Memo: M001-C **Date:** 4 February 2022

Arthur Stanley House

Building services review – noise egress (smoke ventilation plant)

Figure 1 Rooftop plant layout

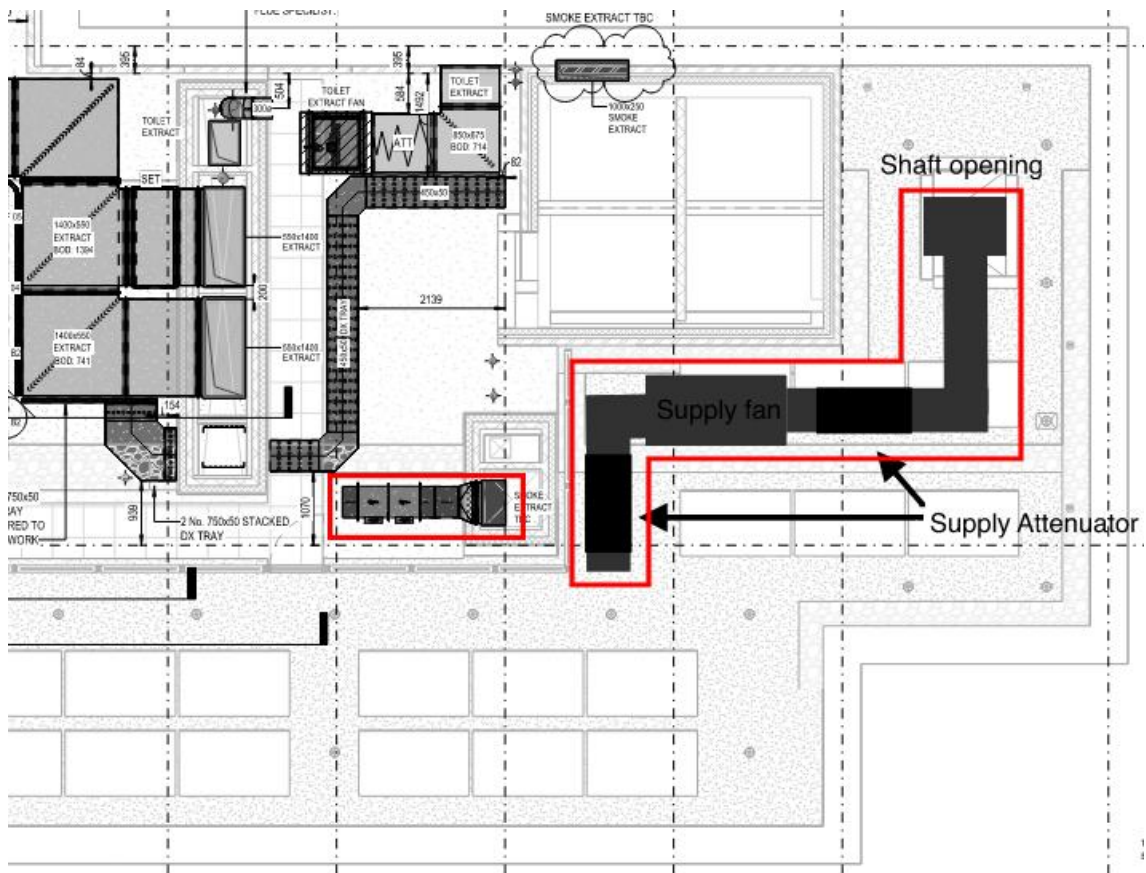
The locations of the proposed smoke ventilation plant have been taken from the drawings provided by 21 Construction and are highlighted in red Figure 1 for reference.

Attention is required to both the supply and extract fans to achieve the emergency plant noise limits.

To achieve the plant noise limits outlined in Table 1, in-duct attenuators are required to the outlet of the smoke extract fan and inlet of the smoke supply fan. The minimum octave band insertion losses and maximum regenerated sound power levels (SWLs) for the required attenuators are given in Table 3.

The above performances can be achieved by attenuators 900 mm – 1500 mm in length. Suitable attenuators are available from IAC (www.iacacoustics.global).

With the provision of attenuators that meet the minimum requirements set out in Table 3 the noise from the smoke extract plant will achieve the emergency plant noise criteria.

Figure 2 Worst affected noise sensitive receptor

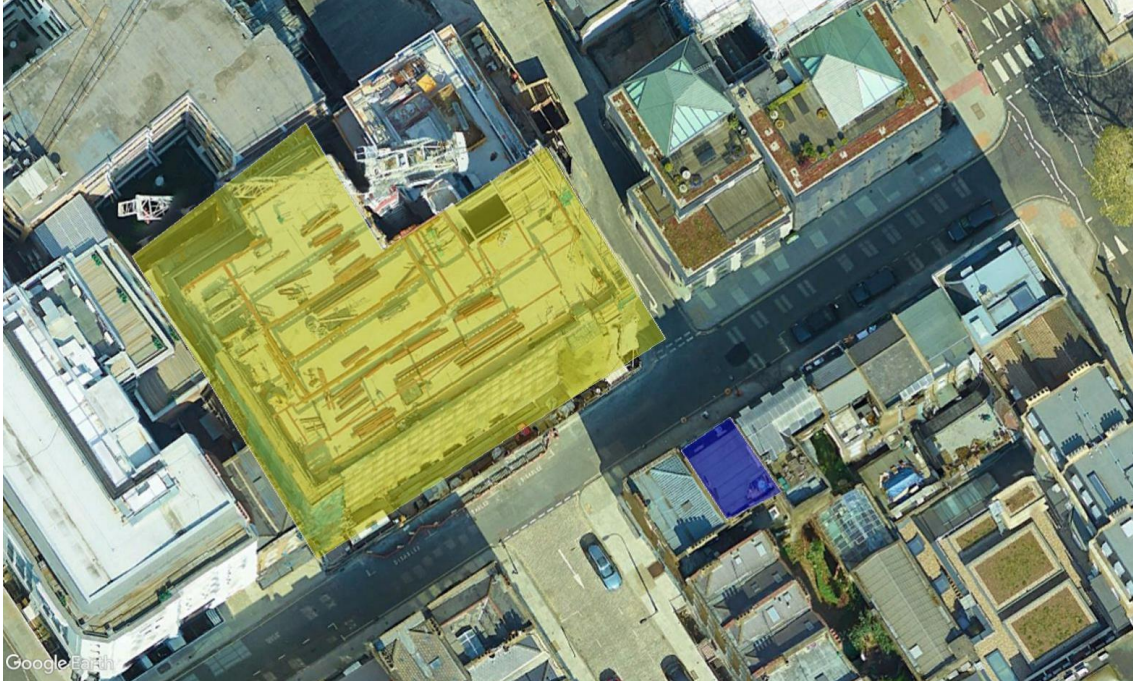
The worst affected noise sensitive receptor has been identified to be the residential premises at Level 4 of 37 Tottenham Street, highlighted in blue in Figure 2.

37 Tottenham Street is located approximately 14 m south of the site at its closest point, and approximately 18-20 m away from the smoke ventilation fans.

Although residential receptors located to the east of site on Tottenham Mews are located closer to the development, they are located further away from the proposed rooftop plant area. In addition to this, residential receptors on Tottenham Mews benefit from additional screening by the building itself.
